RE: RC14513(L) - Coastal Erosion Protection Structure on the Glen Isla Reserve at 95 Seaforth Road, Waihi Beach - GIPS Response to the Request for Further Information

This letter sets out the response from the Glen Isla Protection Society (“GIPS”) to the further information matters identified in the Western Bay of Plenty District Council (“WBOPDC”) letter dated 8 November 2024. The responses are provided in the table below.

RE: RM24-0537-AP - GIPS Response to the BOPRC Request for Further Information

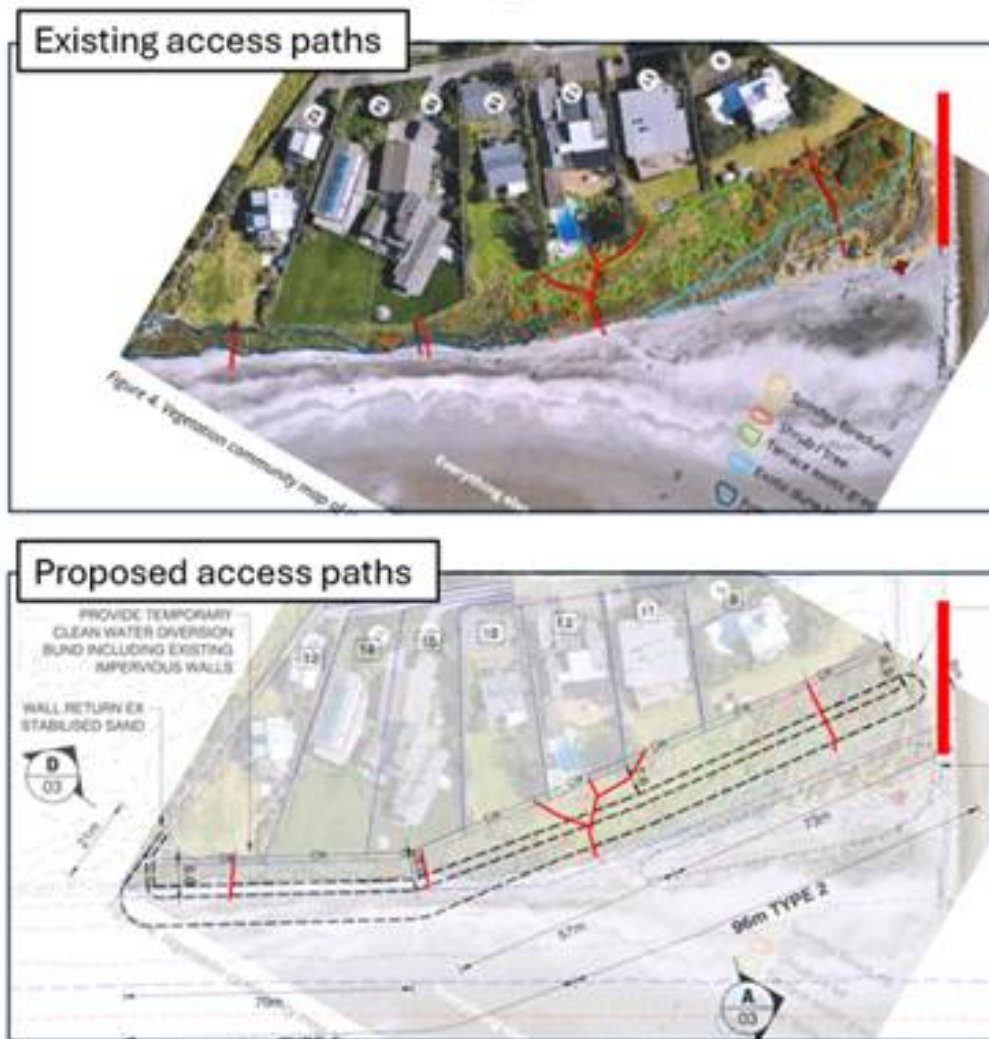
2. The structure design, rock sizing and methodology of placing each rock all work together to minimise any risk of significant depressions or 'sink holes' forming post-construction. Additionally, the covering of the exposed wall with 0.5m of sand from the excavations and recontouring of the dunes following the excavation works will further ensure that any settlement of sand into the spacings between the rock will minimise the likelihood of 'sink holes'. The Project Engineer provided the following comment:

2. As the disturbed sand within the modified dune area settles between the voids of the rock revetment there is a risk of localised sink holes forming, and rocks potentially becoming uncovered due to the settlement of sand. Will the applicant redistribute sand to fill in any sink holes that may appear once the loose sand settles in between the gaps in the rock structure? A suggested condition of consent "visual inspection of the rehabilitated dune to monitor any significant wind erosion and/or sink holes that may have appeared due to the settlement on sand between the voids of the rock revetment". I don't think the monitoring needs to be too onerous or long-term (say at 1, 3 and 6 months after completion), but just long enough to ensure the sand within the disturbed areas has fully settled and the planting has become established.

Any depressions in the sand surface due to sand "arching" between rocks causing unfilled voids in the wall are likely to be localised and relatively small. The provision of 500mm sand cover will address the issue with localised voids quickly being infilled to form depressions. The wall will be completed sequentially and some of the wall will have a number of weeks completed and will be trafficked by excavators numerous times before planting.

A monitoring visit could be undertaken prior to planting. Following completion of the works and planting any settlement that does occur will be minimal and further contribute to naturalised dune contours. Over time, natural dune processes will move sand around the dune environment tending to smooth contours. In an accretionary phase any depressions fill

and an erosion event will completely level contours within the eroded profile. The contours will progressively change naturally over time.

Therefore, the Applicant accepts the inclusion of a condition as follows: *Prior to the replanting of the reinstatement area, the Consent Holder shall undertake a visual inspection of the reinstated dune area within the reinstatement area to monitor any significant wind erosion and/or sink holes that may have appeared due to the settlement on sand between the voids of the rock revetment. Where a depression greater than 0.5m in depth is found, the Consent Holder shall move sand from the surrounding area, using raking (or a similar method), to contour the depression with the surrounding dune height prior to any planting occurring.*
